Response to reviewer comments on:

Omara, M., Gautam, R., et al. Developing a spatially explicit global oil and gas infrastructure database for characterizing methane emission sources at high resolution (<https://essd.copernicus.org/preprints/essd-2022-452/>)

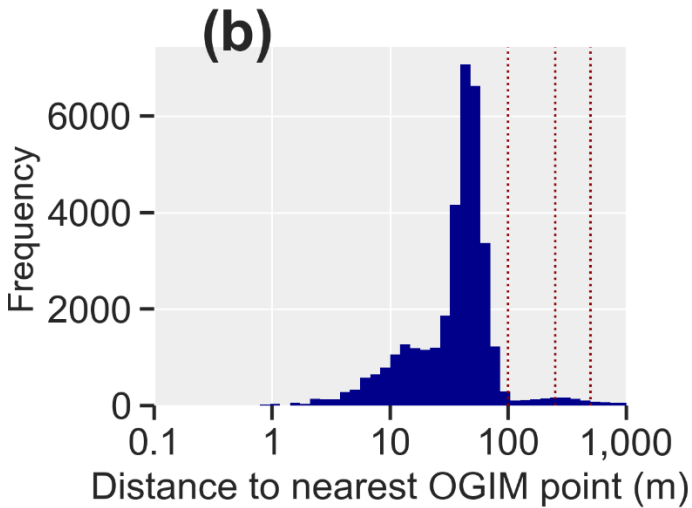
-Related to previous comment: in addition to randomly sampling GIS infrastructure and comparing to visible imagery, why not assemble an independent list of GIS infrastructure solely through visible inspection (say 100 of so in various basins/countries) and then see if your GIS database has elements near your visual list? This would be a more blinded test of gaps in the inventory and spatial accuracy.

We thank the reviewer for this suggestion and acknowledge that such blinded assessments are useful in further assessing the OGIM data coverage and spatial accuracy.

To help provide further assessment of the OGIM data coverage and spatial accuracy, we use a machine-learning derived dataset of oil and gas infrastructure in the Permian Basin, developed by training machine learning (ML) models to automatically detect and classify locations of oil and gas infrastructure in AirBus SPOT imagery (1.5 m pixel resolution) for 2019. Further details of the model development and the ML-derived dataset can be found in Lyon et al. (2020). The original ML-dataset included over 190,000 locations in the Permian, which we filter to 35,107 locations with reported model raw confidence of >95%, indicating high confidence in the likelihood of the model detection being an oil and gas facility. The ML-derived locations are reported for the centroid of the facility footprint based on the satellite imagery. We note that even with this filter of high-confidence detections, it is possible that there are a small undetermined fraction of non-oil and gas infrastructure locations with footprints that are similar in appearance to oil and gas infrastructure footprints in satellite imagery. Nevertheless, this ML-derived dataset represents a very large and independent dataset of oil and gas infrastructure locations in the Permian Basin and provides a unique opportunity for a comprehensive comparison with the OGIM data to further assess OGIM data coverage and spatial accuracy.

For each of the 35,107 high-confidence ML-derived locations, we use a k -dimensional binary tree algorithm to search for its nearest neighbor in the OGIM dataset and compute the distance (in meters) between the ML-derived location and the OGIM nearest neighbor. Setting a distance threshold of 100-m as an approximate dimension (length/width) of the typical oil and gas facility in the Permian, we find 33,620 OGIM locations are within 100-m of the ML-derived locations, suggesting comprehensive coverage (96%) with high spatial accuracy at the set distance threshold. This coverage increases to 97% at 250-m threshold and 99% at 500-m threshold. We note that the Permian is a highly dynamic basin in terms of oil and gas activity, and had ~300 new well pad development per month in 2019 (Lyon et al. 2020). Additionally, public data reporting in this region can have reporting lags of more than three to six months. Thus, while it is possible to track monthly trends in new oil and gas development using machine learning approaches (depending on satellite imagery refresh rate), the public data reporting lag and update frequencies could help explain the <100% coverage assessed herein. A histogram of the computed distances between the ML-derived locations and the OGIM locations is shown in the figure below.

The above assessment provides an independent check on the OGIM data coverage and spatial accuracy in a dynamic oil and gas basin with dense oil and gas infrastructure. Future data verification work should leverage similar approaches to further characterize data coverage and spatial accuracy in other regions, as it is infeasible for us to manually develop, on a scale

suggested by the reviewer, an independent verification dataset based on manual detection and classification of oil and gas infrastructure footprints in satellite imagery.

We include the above assessment as supplementary information to our manuscript.
